Meeting: Traffic Management Meeting
Date: 3 November 2016
Subject: Various Roads in Central Bedfordshire – Consider Objections to Proposed Area-wide Weight Limits
Report of: Paul Mason, Assistant Director Highways
Summary: This report seeks the approval of the Executive Member for Community Services for the implementation of weight limits in Central Bedfordshire

PROPOSED AREA WIDE WEIGHT RESTRICTIONS - VARIOUS ROADS IN CENTRAL BEDFORDSHIRE

Appendix G – Options for Poynters Road

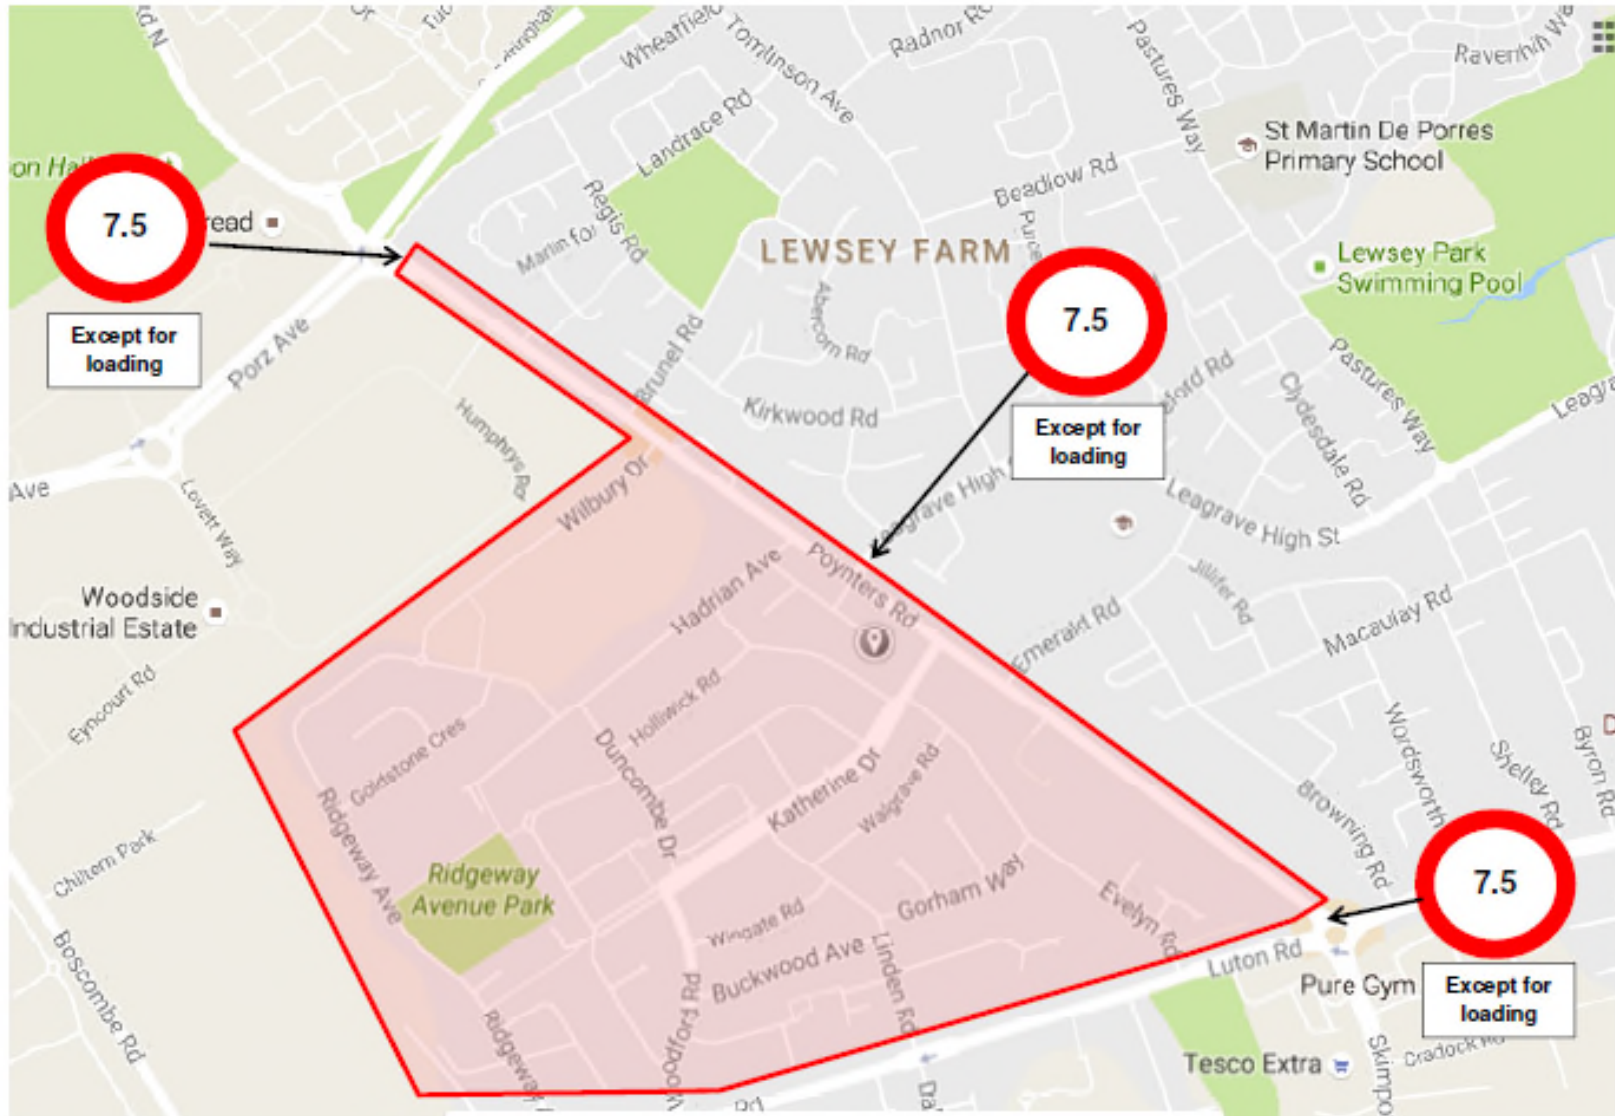
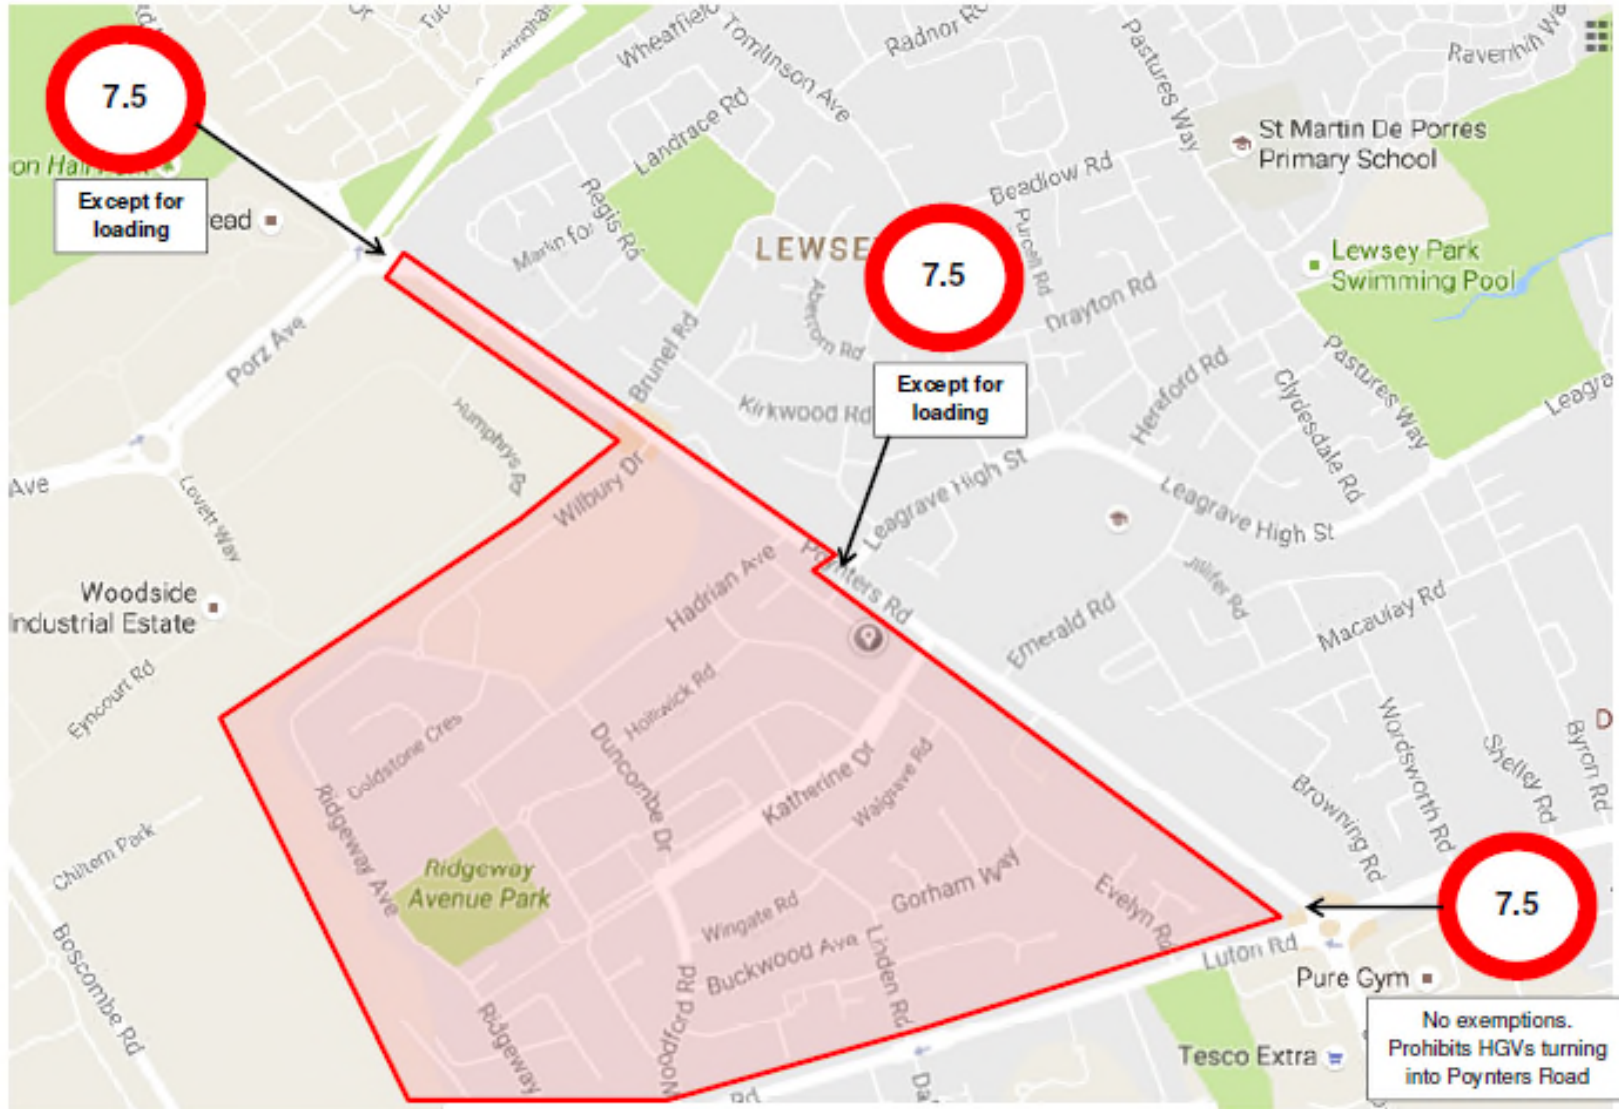
Luton Borough Council has objected to the proposal to introduce a 7.5 tonnes HGV weight restriction on Poynters Road, Dunstable on several grounds, including concerns that it will result in more HGV traffic using Luton's roads. Luton Borough Council has put forward an alternative proposal that would remove their objection.

Advance signing would be needed in Luton to forewarn HGV drivers of the restriction at Poynters Road. This would reduce the likelihood of drivers trying to turn around at Poynters Road/ Leagrave High Street or ignoring the weight restriction. This sign would probably need to be located near to the Leagrave High Street/ Lewsey Road junction, thereby encouraging additional HGVs to use Lewsey Road, which is unacceptable to Luton Borough Council.

- 4) The proposed area wide lorry restriction includes Poynters Road that forms the boundary between the Borough of Luton and Central Bedfordshire. Leagrave High Street, Emerald Road and Brunel Road all join Poynters Road from Luton. Drivers of heavy commercial vehicles will be unaware of the restrictions imposed under the proposed Order on Poynters Road. Central Bedfordshire Council have not indicated that they will fund, provide or maintain signs to indicate the restrictions on roads outside of Central Bedfordshire. This means that all heavy commercial vehicles approaching Poynters Road from Leagrave High Street, Brunel Road and Emerald Road would legally have nowhere to go except undertake a very hazardous multi-point turn on the immediate approach to Poynters Road which would also cause immense traffic congestion on these roads. Articulated vehicles would not be able to make such a multi-point turn within the boundaries of the highway and therefore would be forced into illegally entering the area.

Poynters Road from Porz Avenue to Leagrave High Street would be covered by a 7.5 tonnes weight restriction with an exemption for loading/ unloading purposes. The restricted zone would also cover residential roads in the Katherine Drive area.

In addition a 7.5 tonnes HGV point ban would be introduced to prohibit HGVs turning into Poynters Road from A505 Luton Road. This would contain no exemptions. HGVs would be able to turn left from Leagrave High Street into Poynters Road, thereby spreading the HGV traffic across Lewsey Road and the southern part of Poynters Road.

No advance signing would be needed in Luton as HGVs would be able to proceed south on Poynters Road, effectively providing an escape route.
